Model: Perfect Binder GB5000	Date: 20-June -08	No.: RD391001a
-------------------------------------	-------------------	----------------

Subject: Firmware Release Note: P-Binder_B1		Prepared by: T.Tadokoro	
From: PPBG QA/Service Planning Dept.			
Classification:	<input type="checkbox"/> Troubleshooting	<input type="checkbox"/> Part information	<input type="checkbox"/> Action required
	<input type="checkbox"/> Mechanical	<input type="checkbox"/> Electrical	<input type="checkbox"/> Service manual revision
	<input type="checkbox"/> Paper path	<input type="checkbox"/> Transmit/receive	<input type="checkbox"/> Retrofit information
	<input checked="" type="checkbox"/> Other ()

Subject: STAY: Parts catalog correction		Prepared by: T. Tadokoro	
From: PPBG QA/Service Planning Dept.			
Classification:	<input type="checkbox"/> Troubleshooting <input type="checkbox"/> Mechanical <input type="checkbox"/> Paper path <input type="checkbox"/> Other ()	<input checked="" type="checkbox"/> Part information <input type="checkbox"/> Electrical <input type="checkbox"/> Transmit/receive	<input type="checkbox"/> Action required <input type="checkbox"/> Service manual revision <input type="checkbox"/> Re

19. Inserter Section 13 (D391)

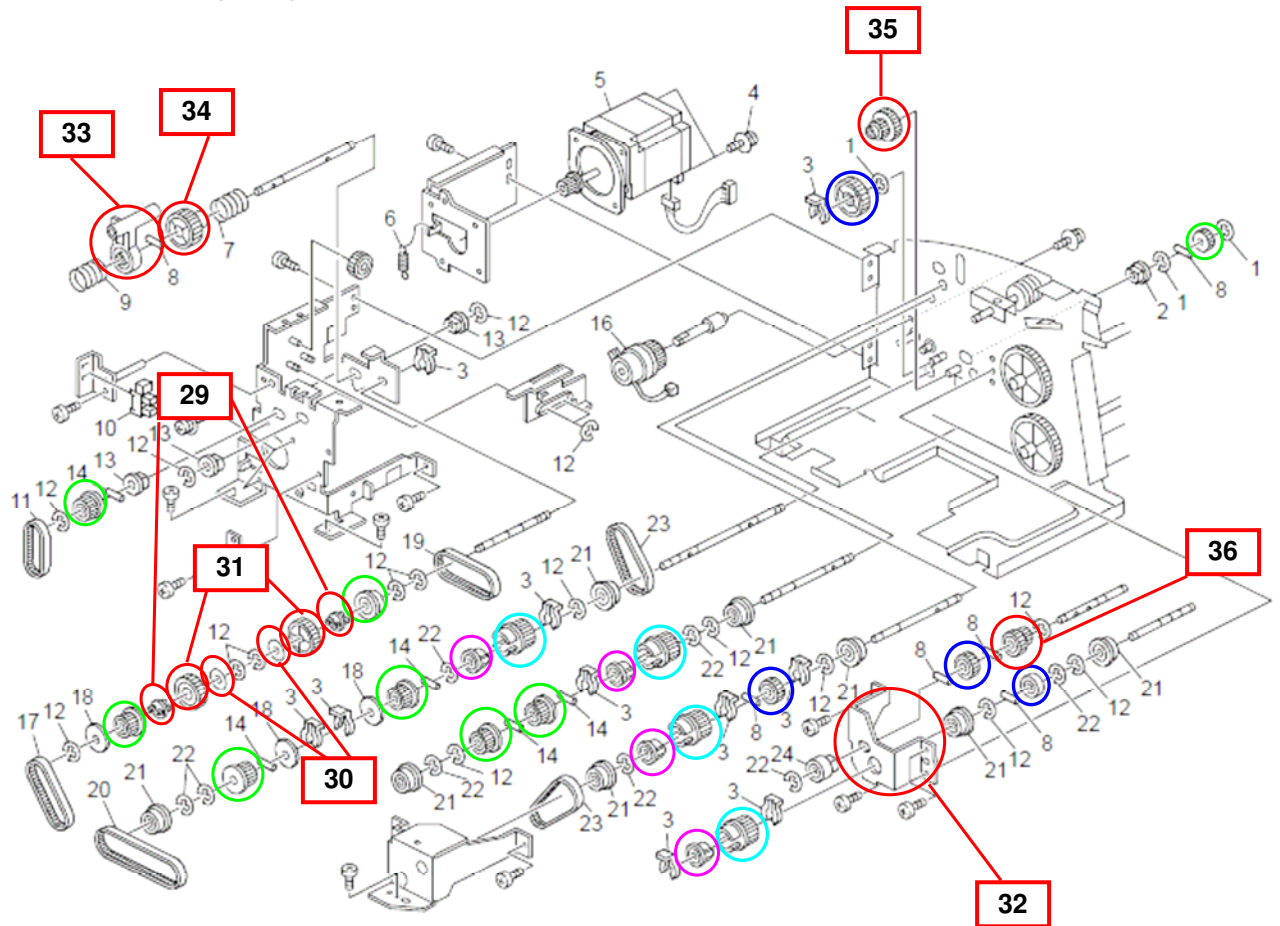
New Part Number	Description	Q'ty	Int	Page	Index	Note
D3911532	TIMING PULLEY:Z18XS3M:PF4051P056	8	-	39	25	Add
D3911644	TIMING PULLEY:T24:PF2269P057	4	-	39	26	Add
D3911529	JOINT:PF2268P344	4	-	39	27	Add
D3911602	GEAR:Z20:PF3091P405	4	-	39	28	Add
D3911638	JOINT:DIA6:PF3091P097	2	-	39	29	Add
D3911640	SLIDER:PW060050	2	-	39	30	Add
D3911641	GEAR:Z30:PF3091P410	2	-	39	31	Add
D3911639	BRACKET:DRIVE:REGISTRATION: PF3091P128	1	-	39	32	Add
D3911642	LEVER:PRESSURE:PF3091P406	1	-	39	33	Add
D3911643	GEAR:Z30:PF3091P085	1	-	39	34	Add
D3911616	GEAR:Z35:PF3091P088	1	-	39	35	Add
D3911603	GEAR:Z20/Z14:PF3091P063	1	-	39	36	Add
